Table 1

| email | SECTION | NUMBER | STYLE/ SUBSTANCE | COMMENT | Assigned to | Accept/Decline | Response |

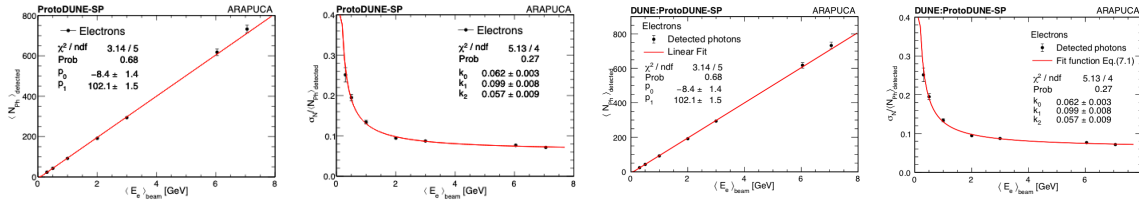
| email | SECTION | NUMBER | STYLE/ SUBSTANCE | COMMENT | Assigned to | Accept/Decline | Response |
|------------------------------------|------------|--------|---------------------|--|--------------|----------------|--|
| | figure | 66 | substance and style | The fitting function should be shown in the legend, For the right side is not given in the caption either. Alternatively, the legends should provide the value of the fit parameters together with their physical units (GeV, GeV ^{0.5}). | FLC | | |

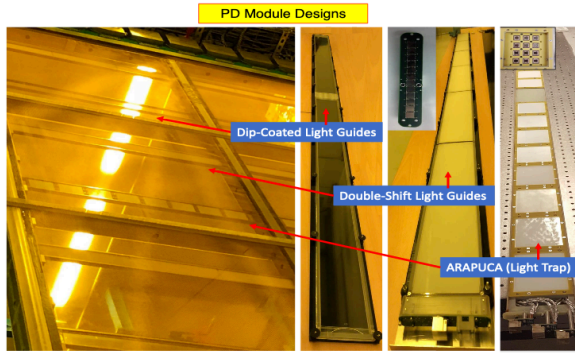
| email | SECTION | NUMBER | STYLE/ SUBSTANCE | COMMENT | Assigned to | Accept/Decline | Response |
|------------------------------------|------------|--------|---------------------|--|--------------|----------------|--|
| | figure | 25 | substance | Figure 25 does not show all details, at least not recognizable for the uninitiated reader. Maybe "some details", or alike? | FLC | | |
| adryanna.major@duke.edu | text | 884 | substance | "Fig 35" should be "Fig 25" | FLC | | |
| | text | 889 | substance | unclear where 4 larger cells are placed within the ARAPUCA module (Fig 25 seems to show only "8" cells design)... Center? Edges? Unclear on motivation for using difference optical areas | FLC | | |
| | text | 915 | substance | "Details are shown in Fig 25", but no details of the photosensors are shown there. Need such a fig added? (Slide 12 has example of this fig https://indico.fnal.gov/event/18460/contributions/47538/attachments/29623/36506/readiness_review_v4.pdf) | FLC | | |

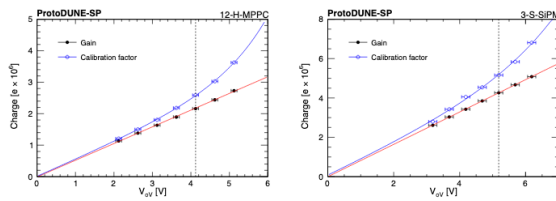
| email | SECTION | NUMBER | STYLE/ SUBSTANCE | COMMENT | Assigned to | Accept/Decline | Response |
|------------------------------------|------------|--------|---------------------|--|--------------|----------------|--|
| | figure | 32 | substance | legend or caption inclusion of blue vs red lines? In line 1088, blue ~ "noise contribution"? | FLC | | |
